Silent Alert Technical Update

Power Supply Compatibility

Current Power Supply (marked Silent-Alert PS3A-2207-EU)

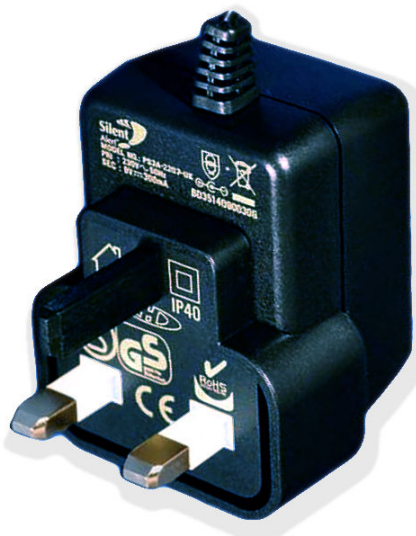
As part of our ongoing programme of product improvement we introduced a smaller Power Supply. Not only is the unit lighter and more compact, it is also clearly marked with our logo to help to identify it as part of our system.

This Power Supply can be used with all Silent Alert Monitors and Alarm Clock or Trickle Chargers produced after the 25th August 2009.

If this Power Supply is used on Alarm Clock or Trickle Chargers produced before 25th August 2009 it can cause the Pillow Pad to run constantly and may damage the Pager battery.
